Gartner Lee Limited

June 20, 2005

Re: GLL 50-506 – Review of 2004 DDMI Aquatics Effects Monitoring Program Report

Figure 1: Total Ammonia – Near Field Results

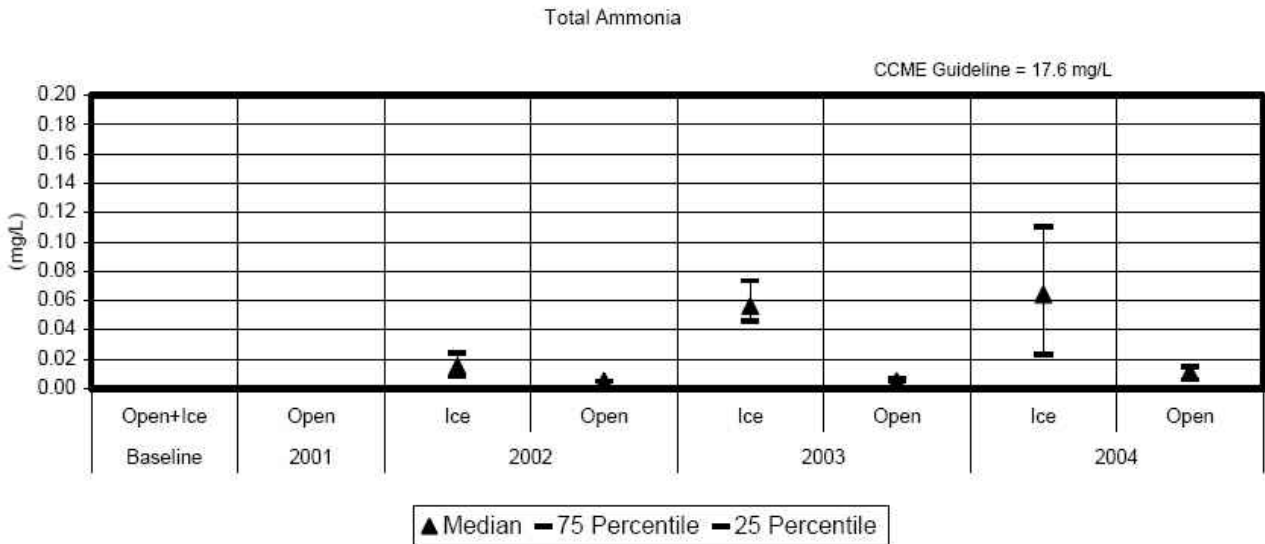
There is an obvious seasonal variability in some of the parameters (such as ammonia), with the under-ice concentrations being substantially higher than those during open water. There is also an apparent increasing trend in the concentrations of under-ice ammonia (See Figure 1). Given that there are now 3 years of post-baseline data, it may be more appropriate to consider under-ice and open water samples separately, particularly for non-conservative substances such as ammonia.

Given that there are now 3 years of post baseline data, DDMI should apply the AEMP data analysis to the under-ice and open water samples separately to delineate any seasonal trends in Lac de Gras.
